**CONTRACT CHANGE ORDER**

Contract No. BLDG-2019-45 for the following public work: Myrick Park Water Utility Storage Building

**Date:** November 21, 2019 **CB #:** 3 Relocate Underground Service Conduit

**Date:** March 18, 2020 **CB #:** 5 Add Catch Basin/Piping and Revised Drive Layout

**1 ELECTRICAL SITE PLAN**  
 E001.1 SCALE: 1" = 30'-0" 1901-A-SITE

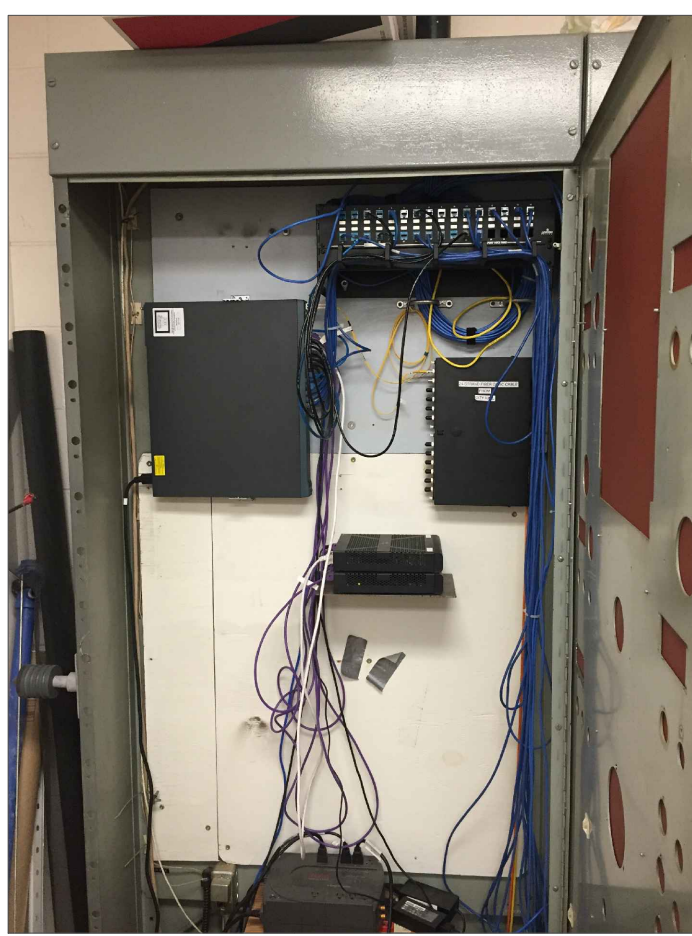
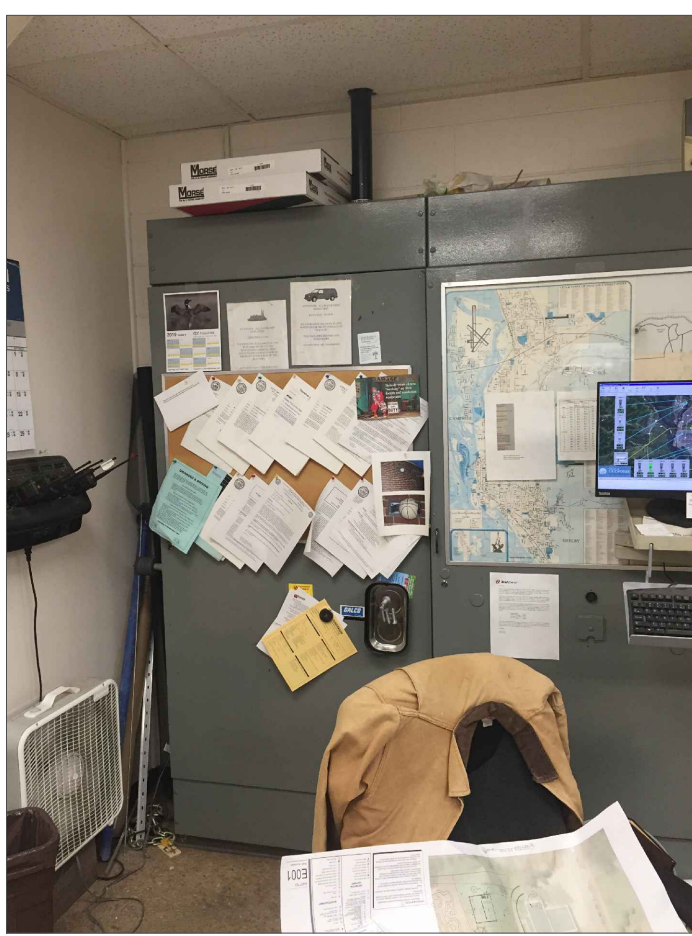
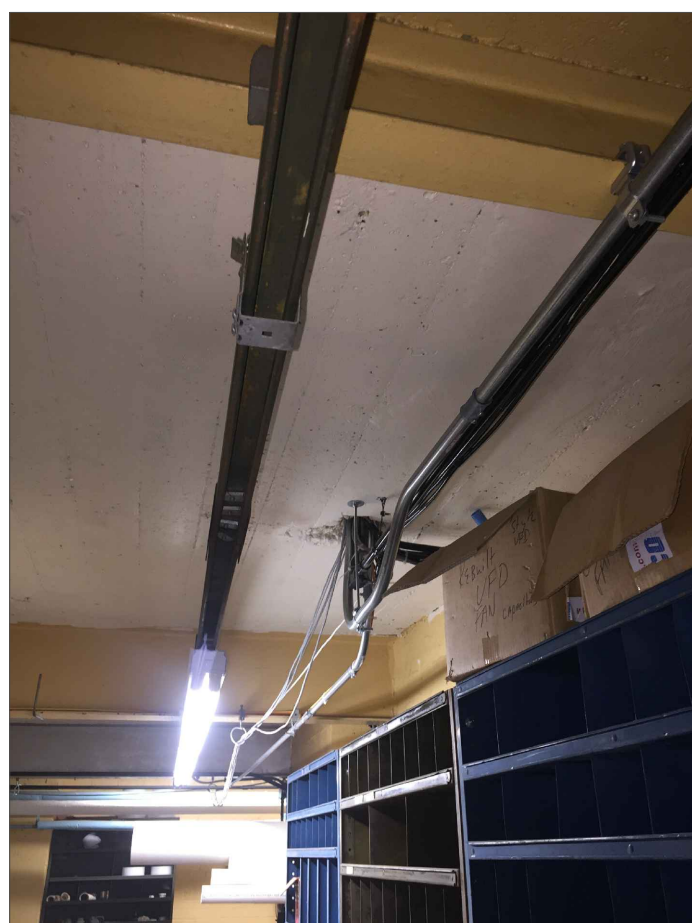
**Drawing #(s):** E001.1 – Site Plan **Specification #(s):** N/A

<b>Description:</b>	<b>Please Respond By:</b> N/A
<p>Sheet E001.1 – Electrical Site Plan:</p> <ul style="list-style-type: none"> <li>Refer to ‘clouded’ changes labeled ‘CB3’ relocating 4” schedule 40 PVC underground service conduit approximately 50’-0” to the West. Refer to Keyed Site Plan notes #1 &amp; #2 on attached drawing.</li> </ul> <p>GALILEO CONSULTING GROUP, LLC PAT POPOWICH/ELECTRICAL DESIGNER, PRINCIPAL</p>	
<input checked="" type="checkbox"/> Attachment(s)      E001.1 – Site Plan	<b>Prepared by:</b> Pat Popowich Galileo Consulting Group, LLC

<p><b>Response:</b> Electrical Subcontractor \$1,945.05</p> <p>Olympic P&amp;O 15%                      \$291.76</p> <hr/> <p>Total                                      ADD                      \$2,236.81</p>
<p>Response prepared by:    Jason Yahnke/Cab</p>
<p>Date response sent:    12/4/2019</p>
<p>Cc:</p>

SHEET NO.  
**C200**

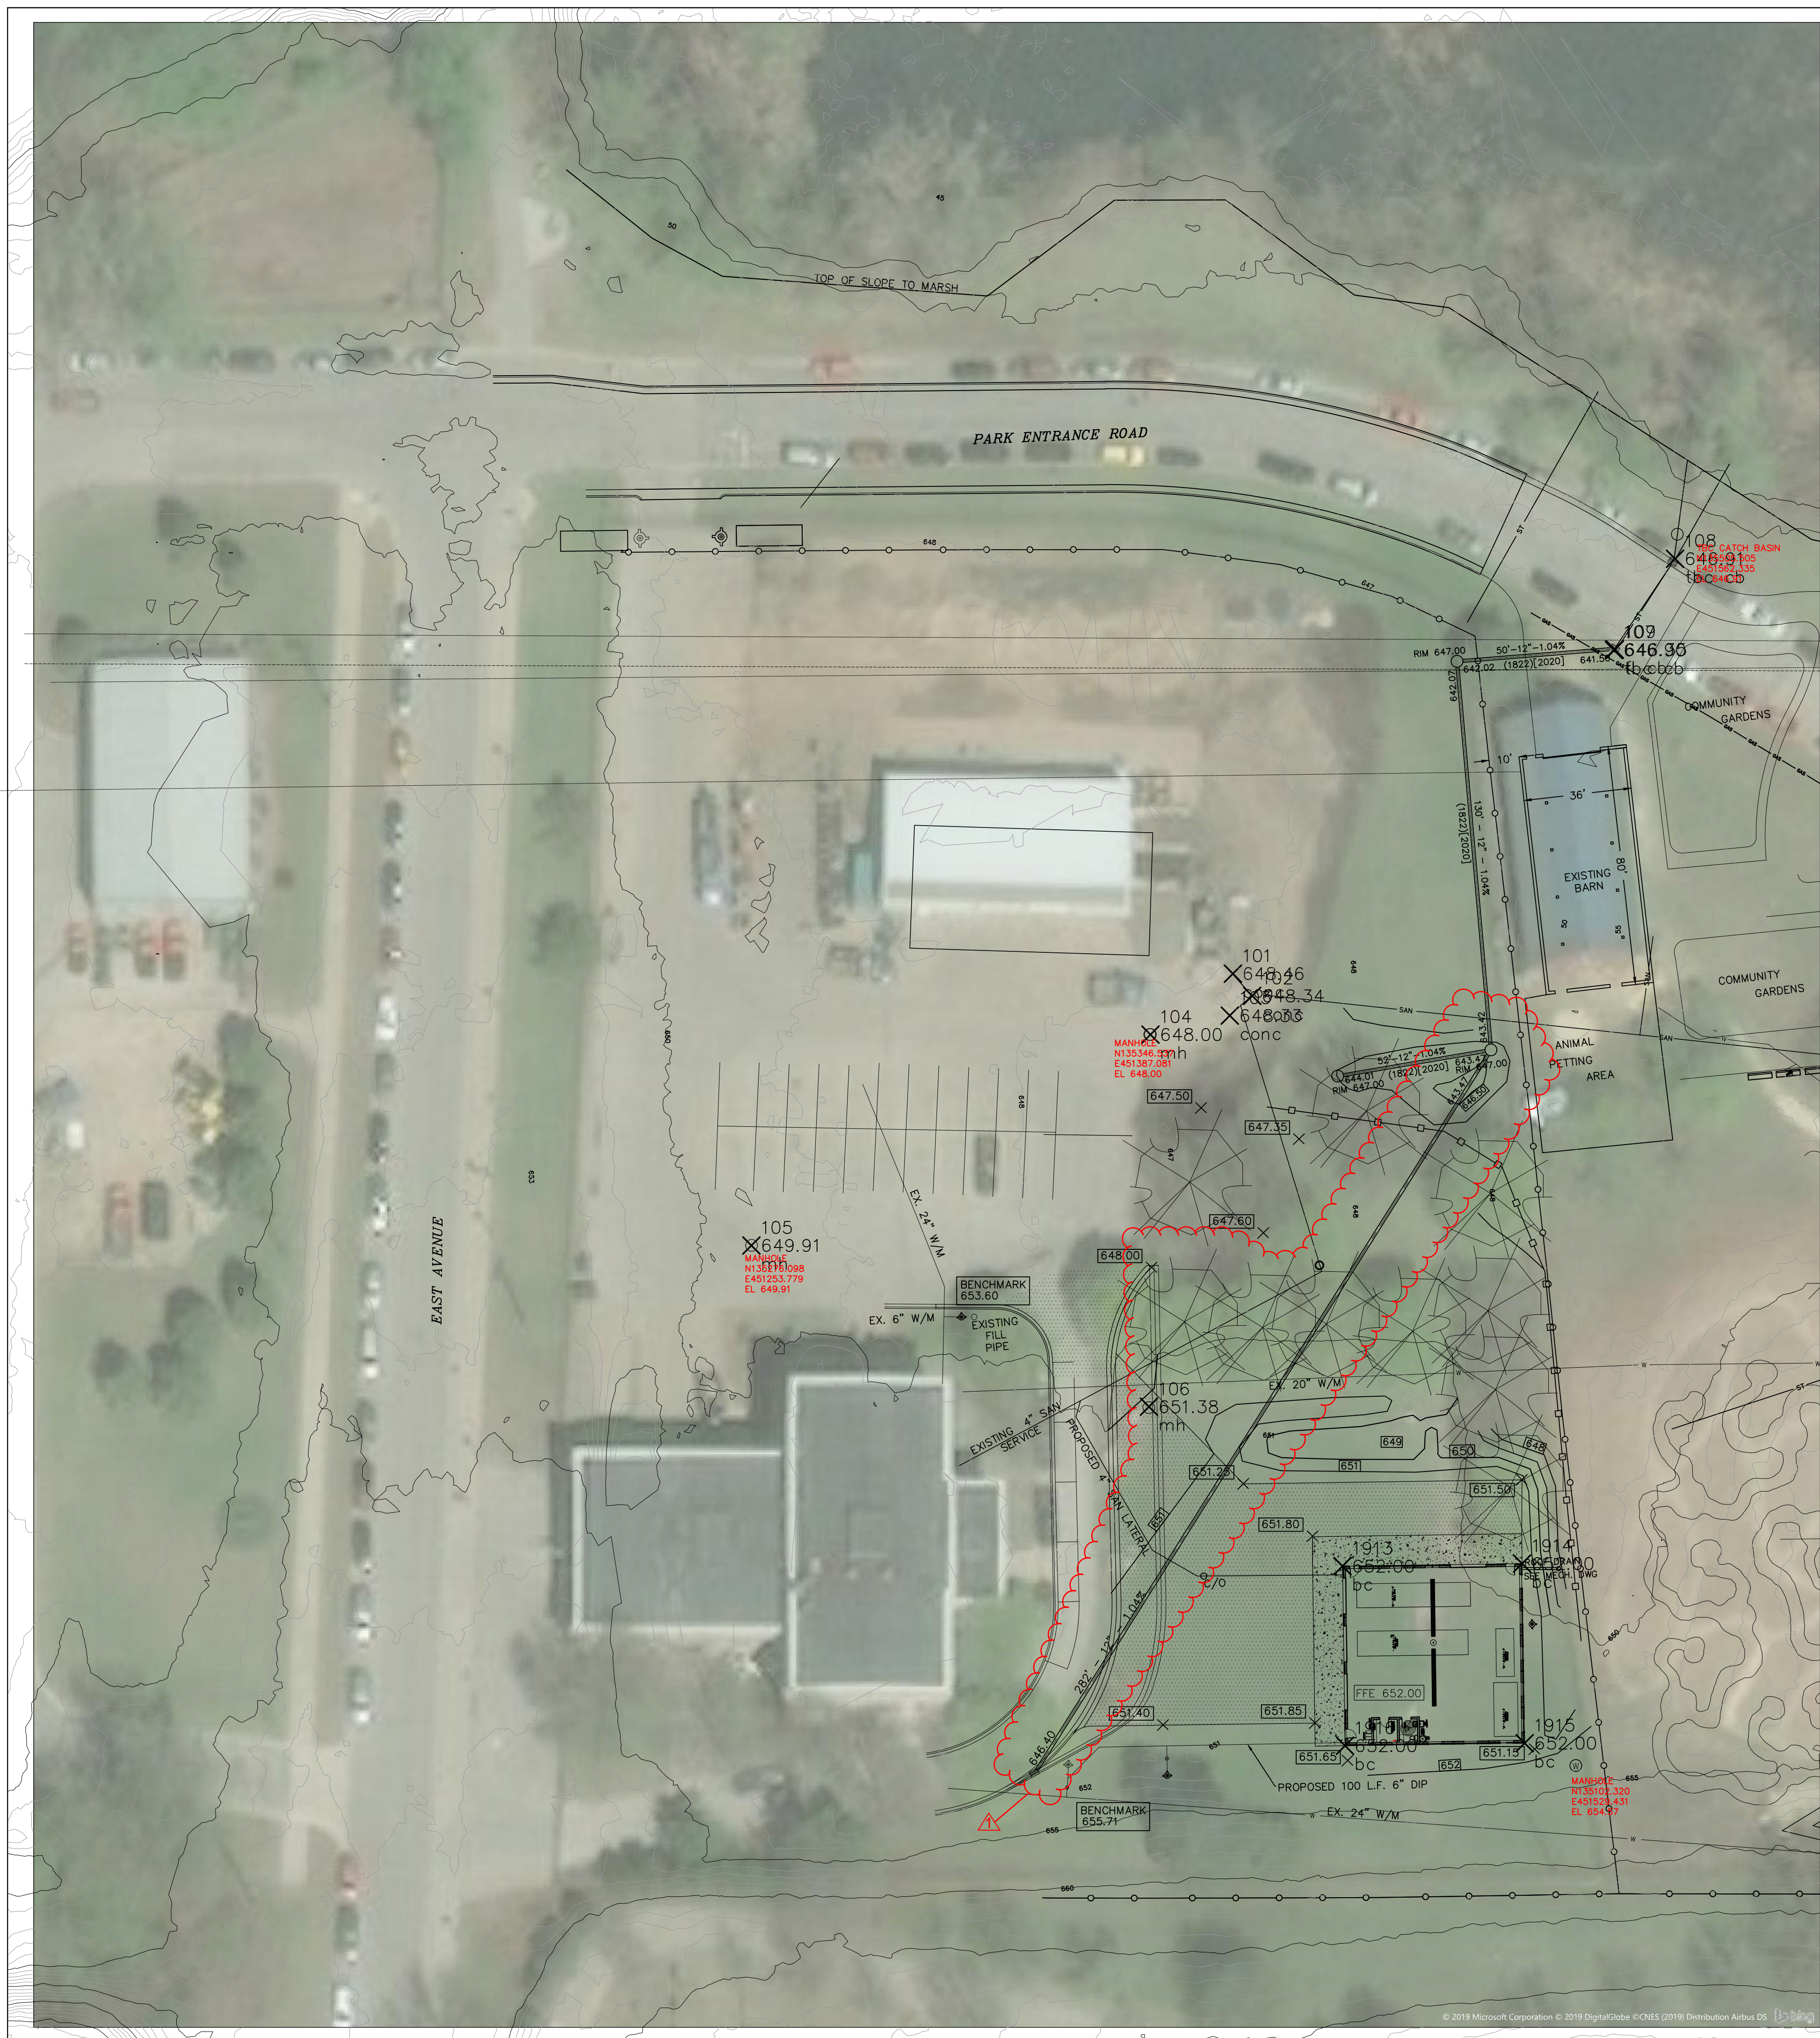
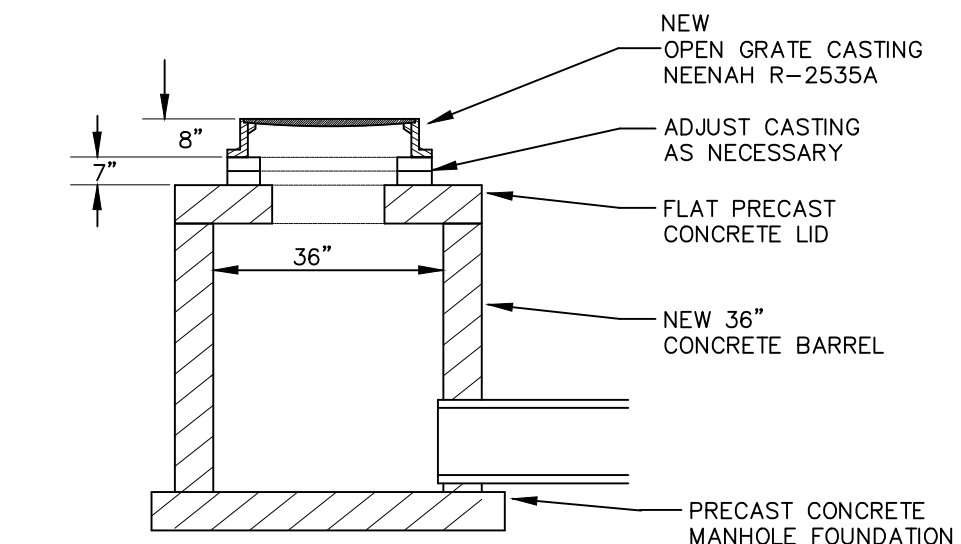
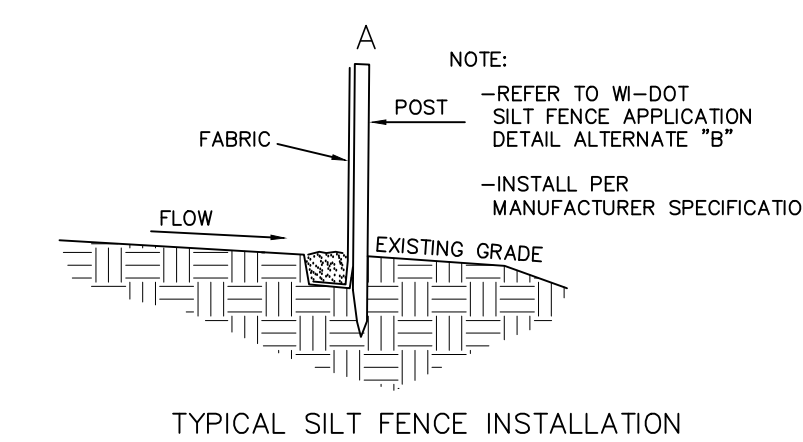
**Drawing #(s):** Sheet C200 **Specification #(s):** N/A

<b>Description:</b>	<b>Please Respond By:</b> N/A
<p>Identify the cost to furnish and install the following:</p> <ul style="list-style-type: none"> <li>a. Revise width of drive from 18' wide to 34' wide. Relocate/modify concrete curb and concrete drainage flume as shown on plan. Provide additional paving base material as needed.</li> <li>b. Add 282' of 12" drainage pipe and one catch basin as shown on revised Sheet A200. Connect to proposed concrete man hole per previous plans.</li> </ul> <p>See attached revised Sheet C200 dated 3.18.2020</p>	
<input checked="" type="checkbox"/> Attachment(s)      Revised Sheet C200 Dated: 3.18.2020	<b>Prepared by:</b> Jerry Schomberg Vantage Architects, Inc.

<b>Response:</b>	Site Utilities Subcontractor	\$11,225.00
	Olympic-Additional curb & gutter - 30' @ \$35.00 ft	\$1,050.00
	Additional seeding	\$4,050.00
	<hr/>	
	Subtotal	\$16,325.00
	Olympic 15% P & O	\$2,448.75
	<hr/>	
	Total	ADD \$18,773.75
